Regarding Council meeting 2/26/19
Agenda #6.2 Increased building height proposal
Request supplemental study to be completed

RE: Support for Scenario #4 - One-Engine Inoperative (OEI) change as recommended by the Downtown Airspace and Development Capacity Study

Re: Council Agenda Item 6.2 Actions Related to the Downtown Airspace and Development Capacity Study.

Subject: Scenario 11 - Runway Extension - Please add this to the public record for 18-1944

Figure 1, From May 2018 OEI Presentation

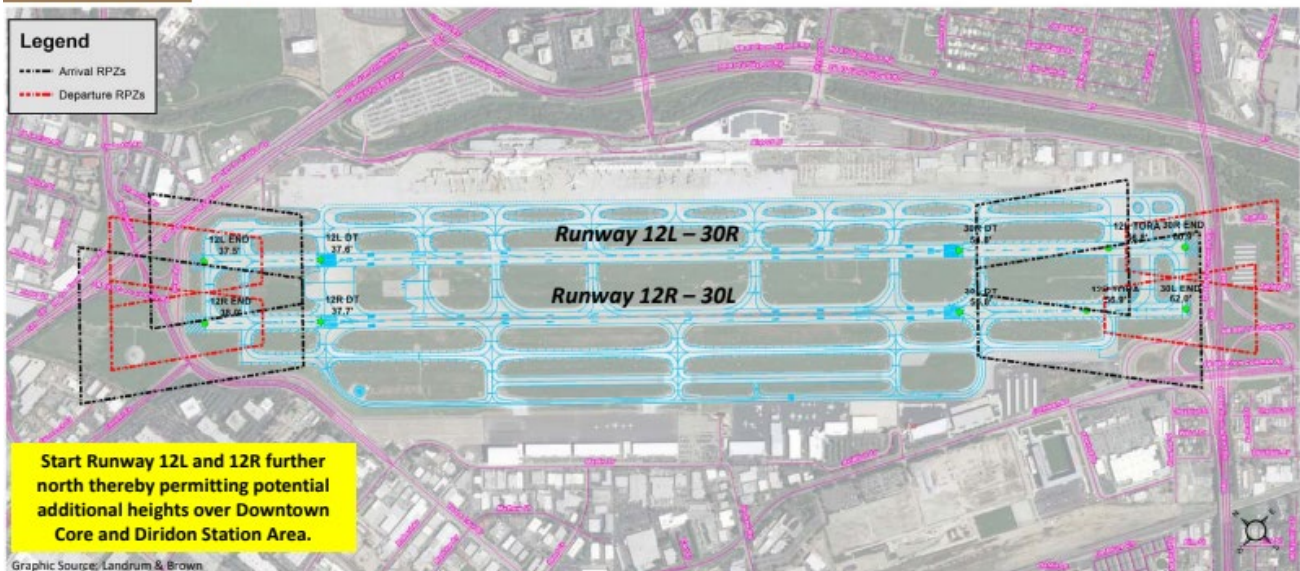
In the documentation provided by the Airport, the only reference to extending the runway was provided in this slide in a May 2018 presentation. There was no explanation of what had been examined in this so-called Scenario.

SCENARIO #11 – EXTEND THE APPROACH ENDS OF RUNWAYS 12L AND/OR 12R TO THE NORTH

Figure 2, Rough Sketch of Runway Extension over De La Cruz

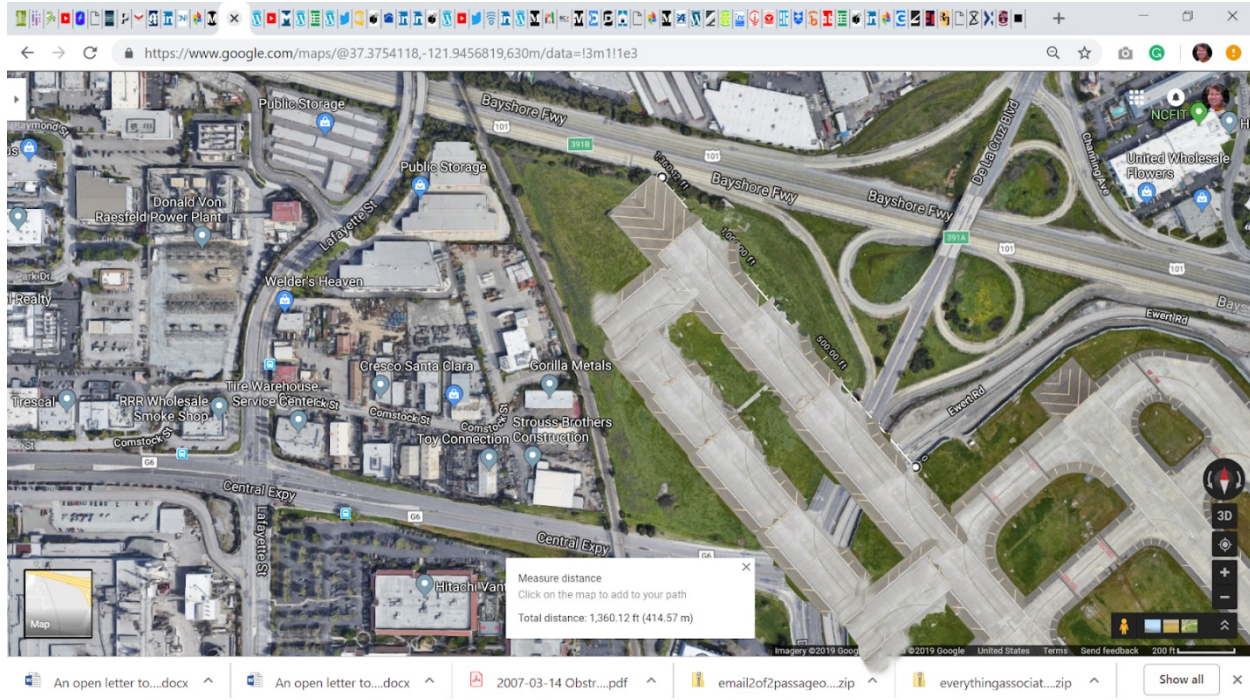
Perhaps, the slide that should have been created is below, which depicts a runway and taxiway extending over De La Cruz Avenue to the field where the FAA's antenna field is. At some point in the not-too-distant future, the FAA plans on decommissioning that obsolete radio facility, freeing up the land for other uses (within bounds of airspace restrictions), such as a runway extension.

Would extending the runway necessitate an extension beyond the freeway, etc.?

Hopefully not, as the extended part of the runway (on the north side of De La Cruz) would only be used for take-offs. Page 3-13 of the Comprehensive Land Use Plan for Santa Clara County indicates that there must be a runway protection zone.¹

There is no reason that a longer runway would need to change the displaced landing thresholds.
